World Forum for Harmonization of Vehicle Regulations

Working Party on Brakes and Running Gear

Tyres – Regulation No. 54

Proposal for amendment to Regulation No. 54 (Tyres for Commercial Vehicles and their Trailers) and Regulation No. 117 (Tyres, Rolling Resistance, Rolling noise and Wet Grip)

Annex 3, replace:

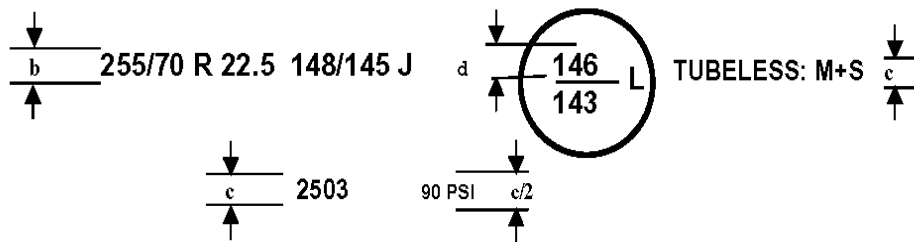
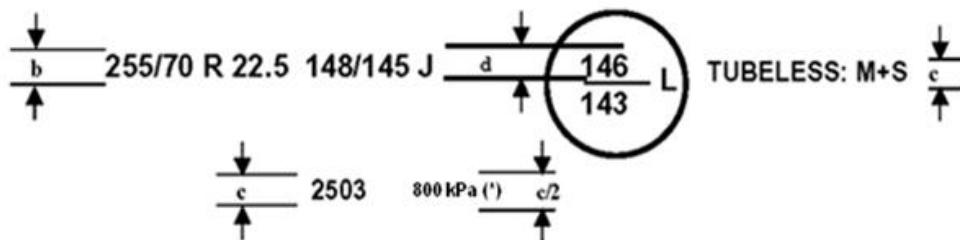
For tyres first approved after 1 January 2018, the inflation pressure for the dimension measurement and for the load/speed endurance test, pursuant to paragraph 4.1.12 of this Regulation, shall be indicated in kilopascals, replacing the "PSI" index. "

It is proposed to replace the PSI Index by indicating the inflation pressure in kilopascals ("kPa"). By this, it will become possible to mark the same pressure as in all major tyre standards and avoid confusion in case of tyres marked according to UN Regulation N°. 54 and, at the same time, according to FMVSS 119 or FMVSS 139.

(*) PSI marking instead of kPa may be used for tyres first type approved before 1 January 2018. "
